**RE: First Avenue, Silver Spring, Maryland**

I have enclosed the front and right side elevations for Lot 16 on 1<sup>st</sup> Avenue. Unfortunately, it has been discovered that a dormer is necessary, in order to have adequate clearance in the stairs to the attic. After doing some analysis on the other lots, we believe that a dormer will not be necessary on the other two houses. This being the case, it will make Lot 16 even more of a one of a kind home.

#0015 1ST AVENUE  
 LOTS 17, 16, 10 & 11  
 BLOCK 5, WOODSIDE  
 SITE PLAN

RIGHT SIDE ELEVATION

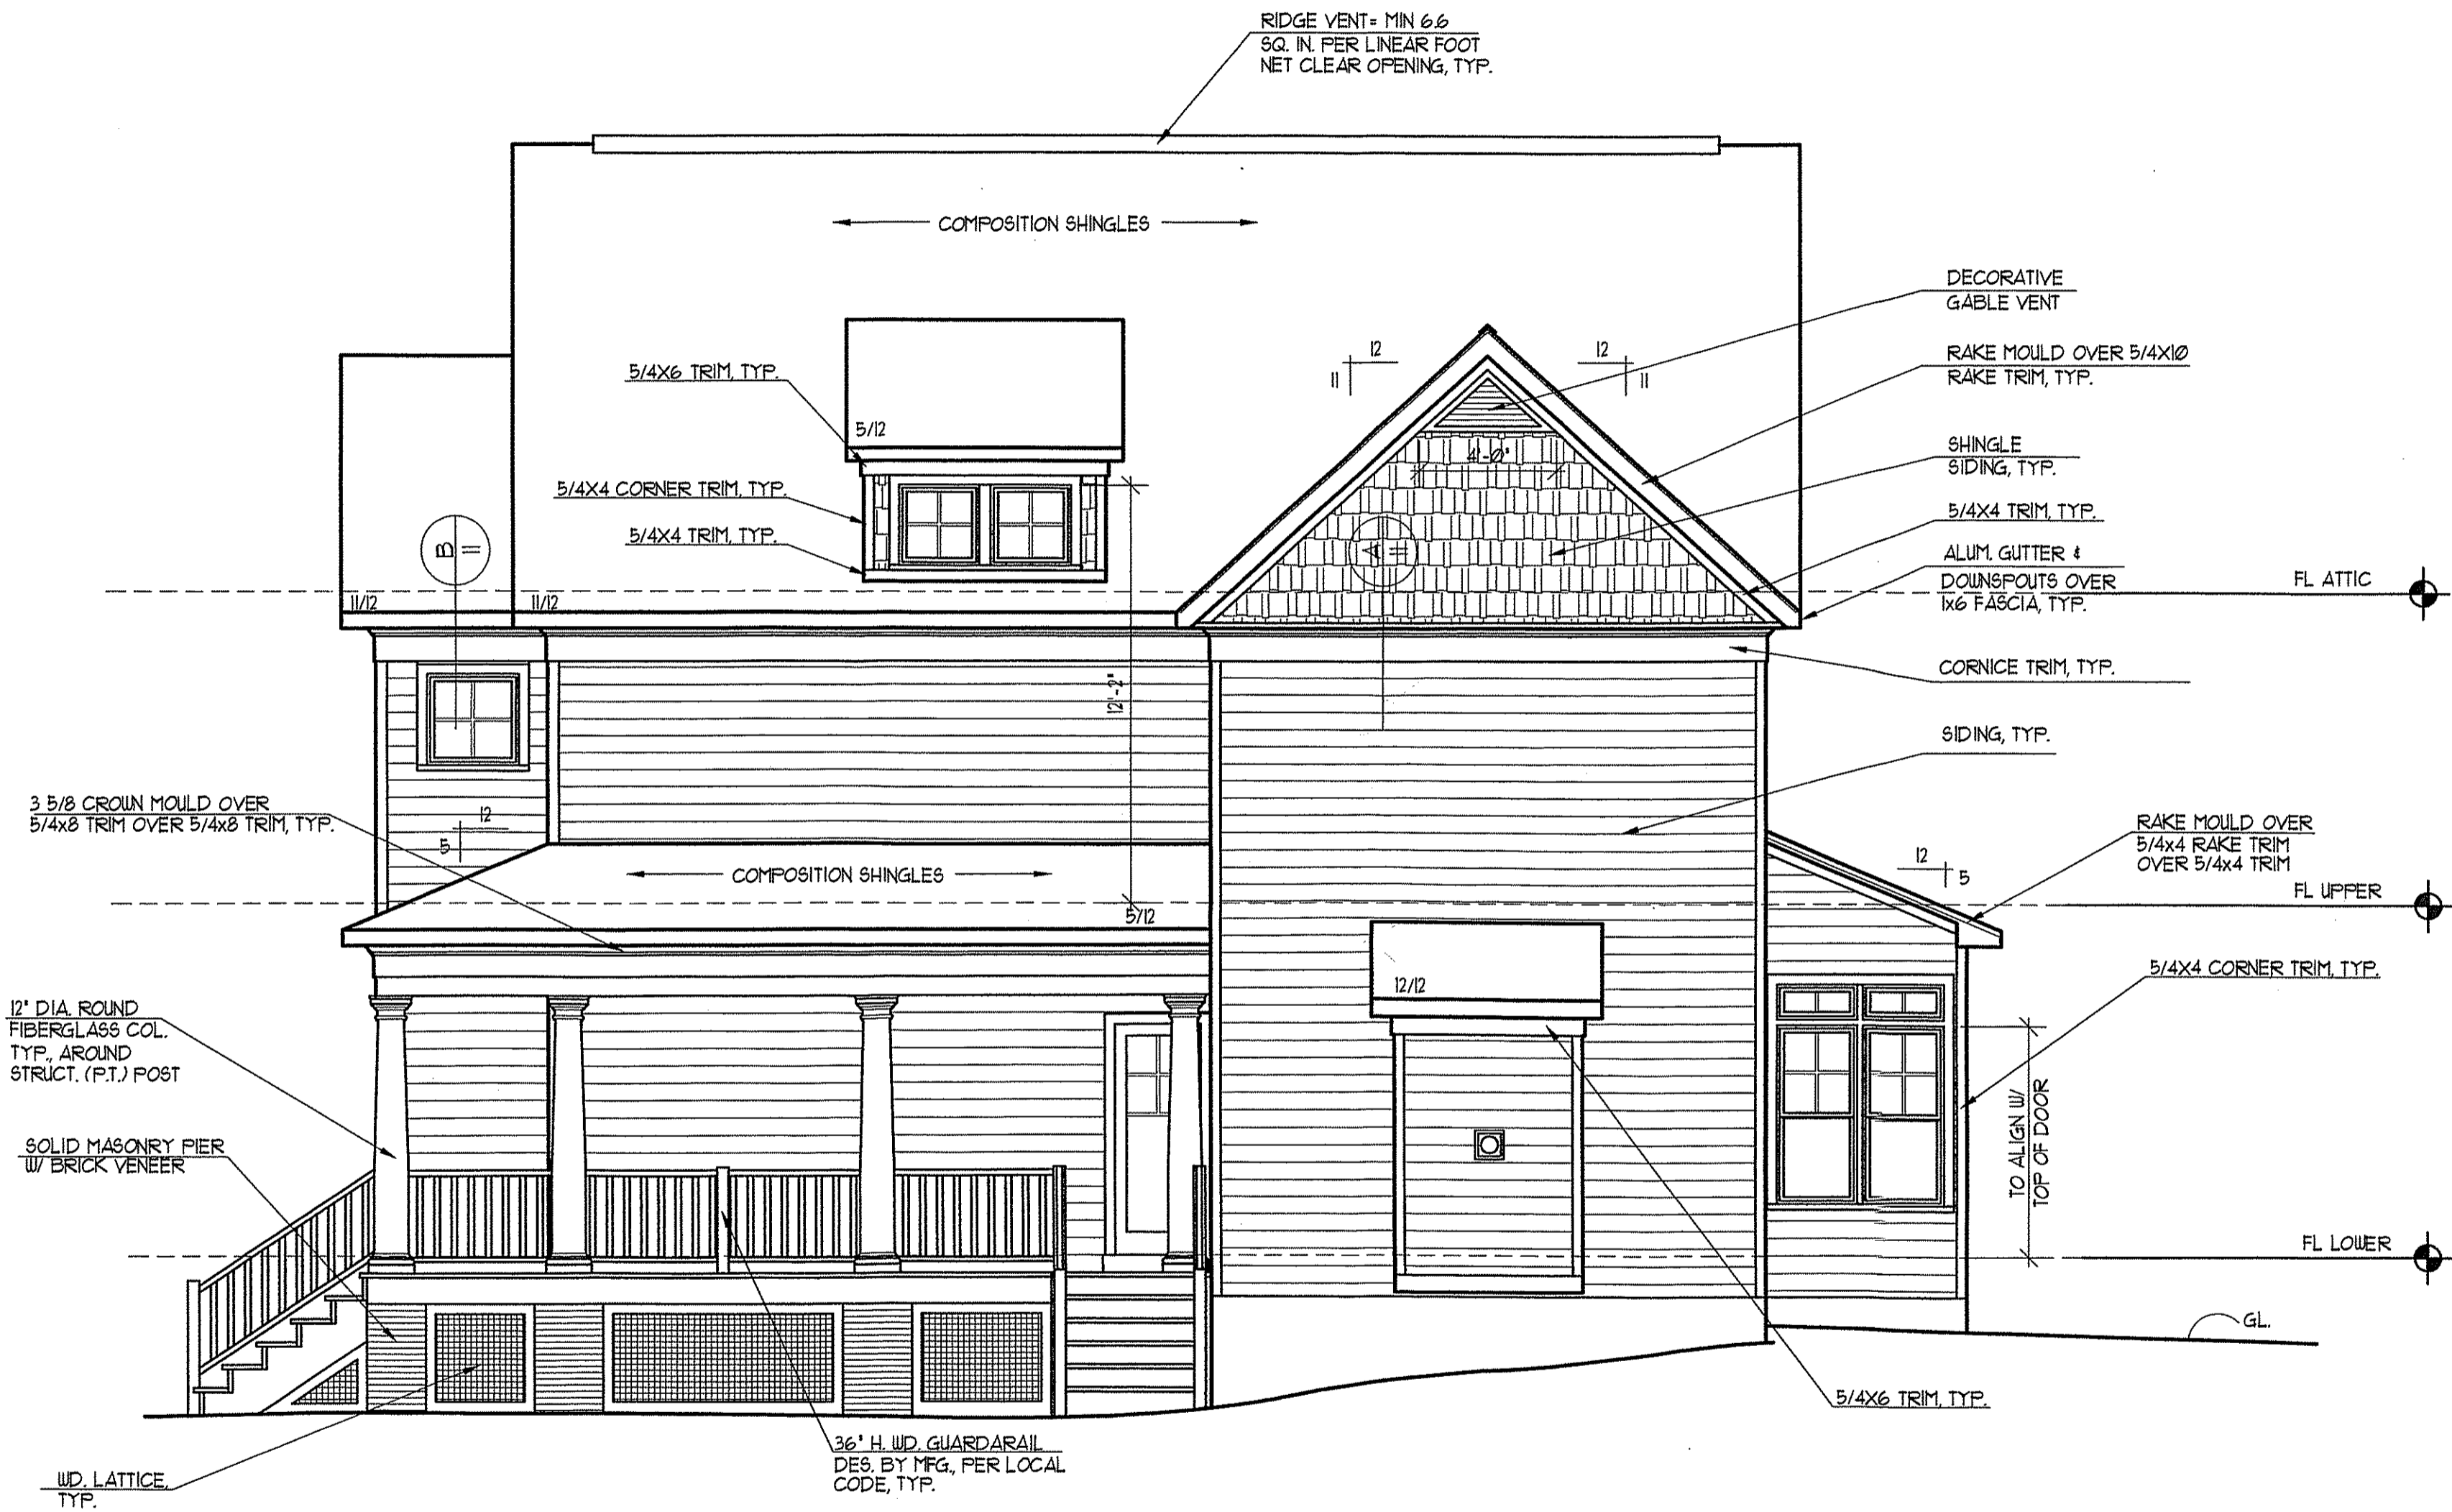
2. – Lot 17 - The Staff and Commissioners through the hearing and in Commissioner Spurlock's summary expressed that perhaps additional architectural interest should be added to the right side elevation.

Answer- The Applicant has redesigned the right elevation of the home providing better balance with the windows and added a gable to give the home more of a "dual front" design. Additionally, the Applicant reduced the pitch of the roof from 10/12 to 9/12 or 10% which resulted in a reduction in the height of the ridge of approximately 2'.
